Tender Addendum

Addendum Number: T002

Tender: T018 23/24 South Boulder WWTP Inlet Works Structure

TYPICAL WELD – FLANGE WELDING

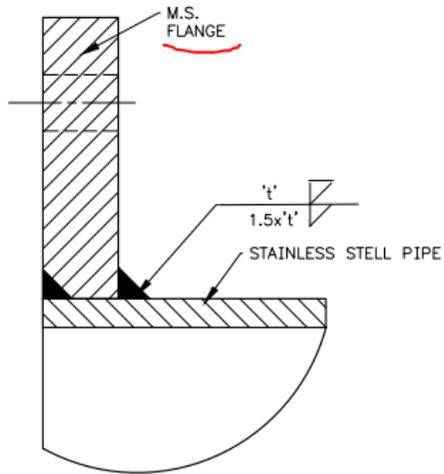
DRG No 1034-03-08-DWG-014 Rev0 Item 7D

Item 7D has a mild steel flange welded to a stainless pipe with a 309 consumable. Can I suggest to have a stainless flange and then a dissimilar metals isolation kit (mylar sleeve/G10 washer) fitted at bolt up?

Typical Weld detail: M.S. flange should be stainless steel flange. E309MoL is austenitic stainless steel so will all be similar materials.

The fixings are specified as SS316 but the flange isolation kit is acceptable. If the bidder is concerned about price-competitiveness offer of improved fixings etc (such as isolation kit) can be listed as provisional sum offering.

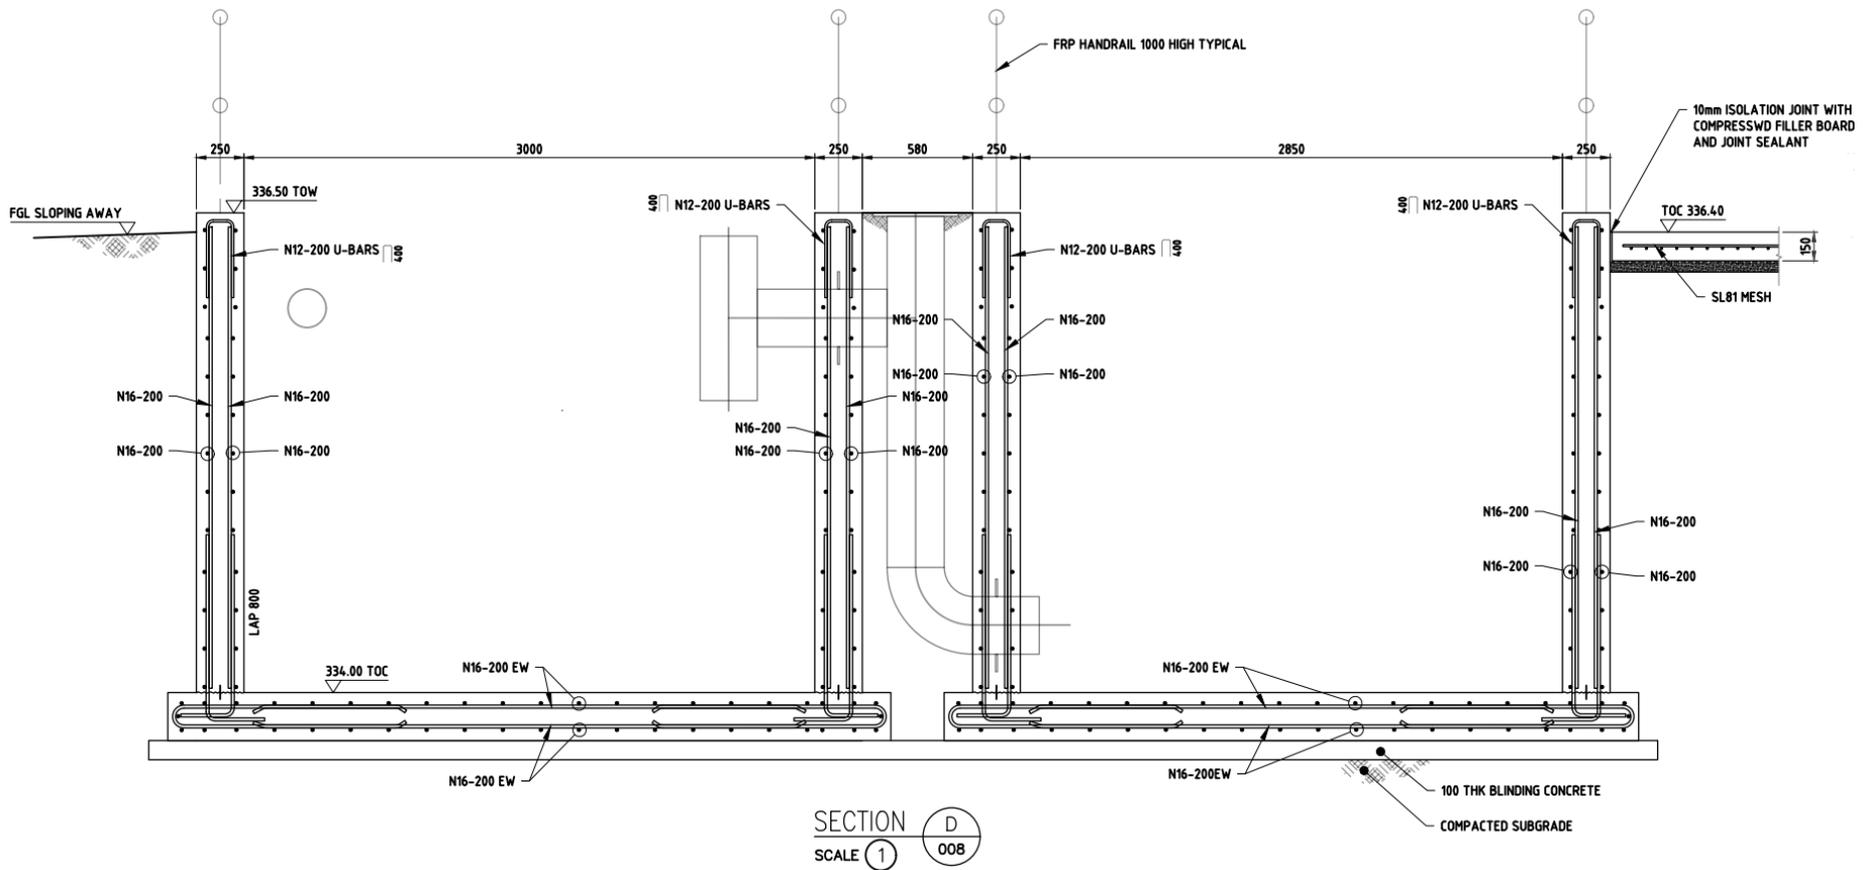
Can the client please confirm reinforcement and typical details on the walls for both grit sump and the liquid waste pit, as it is not identified with typical sections on 1304-03-08-DWG-008?

Details are provided in drawing 1304-03-08-DWG-010 section D.
